Service Letter No. 398

SUBJECT: Replacement of "O" Rings in Fuel Control Valves

MODELS AFFECTED: PA-23-235 Apaches, Serial Nos. 27-505 to 27-528 incl., 27-530 to 27-536 incl., 27-542 and 27-548

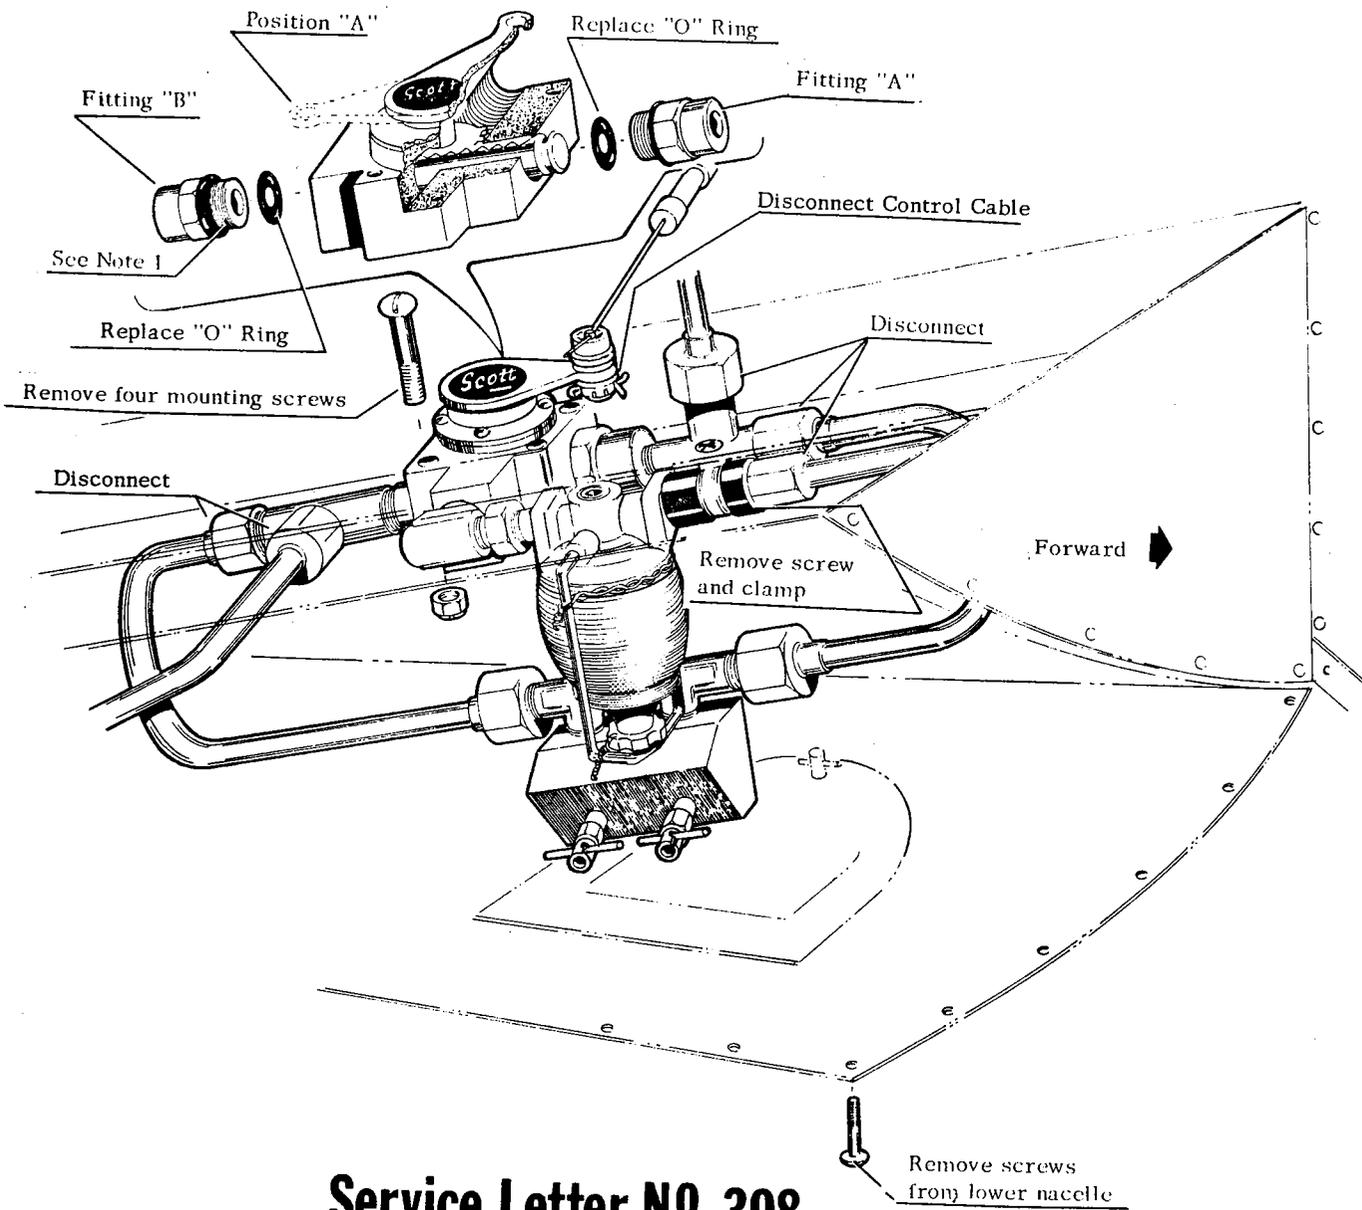
We have received a few reports indicating that some difficulty has been encountered in making fuel tank selections when operating in low temperatures. The "O" rings in the Scott fuel control valves tend to harden in low temperatures and produce a binding effect within the valves.

It is required that the "O" rings in the left and right fuel control valve, part number 30857-00 and part number 30857-01 respectively, be replaced in these valves. See sketch and detailed instructions on the reverse side of this letter.

Since all fuel must be drained prior to the installation of the "O" rings, it is suggested, if possible, that the replacement of "O" rings be accomplished prior to refueling.
